DRAFT MINUTES MHCC STRUCTURE & DESIGN SUBCOMMITTEE MEETING

December 10, 2015

APPENDIX B: PROPOSED MODIFICATION TO LOG 87

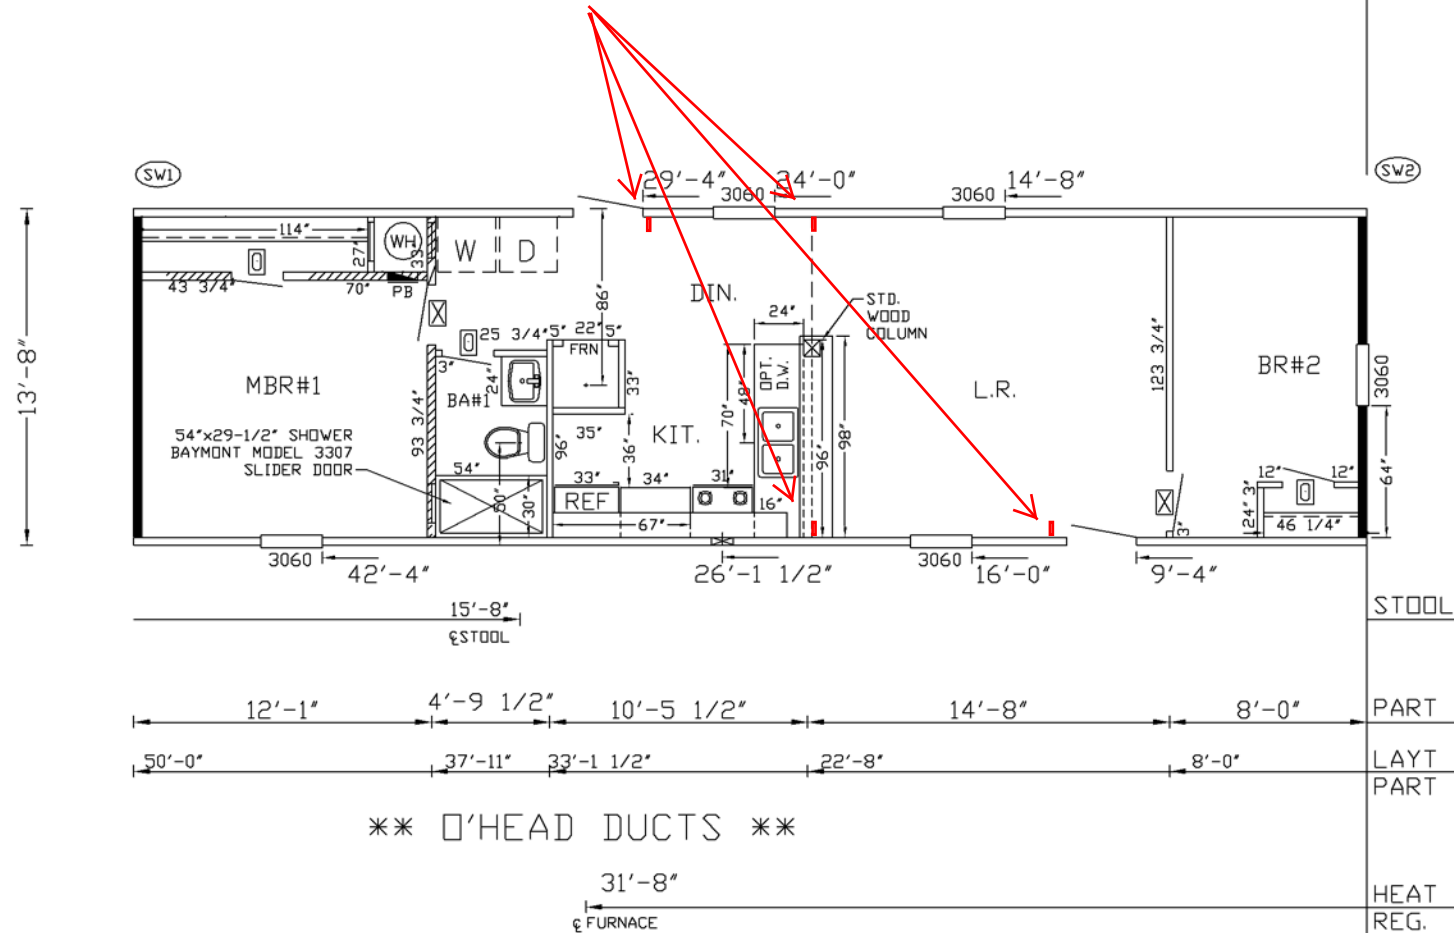
NTA recently received a deviation from HUD, and was unsuccessful in disputing it concerning floor plans similar to this one
HUD is insisting that a full height at one of the locations show in order to provide a 'seperation' between the exterior doors.

Suggested wall locations
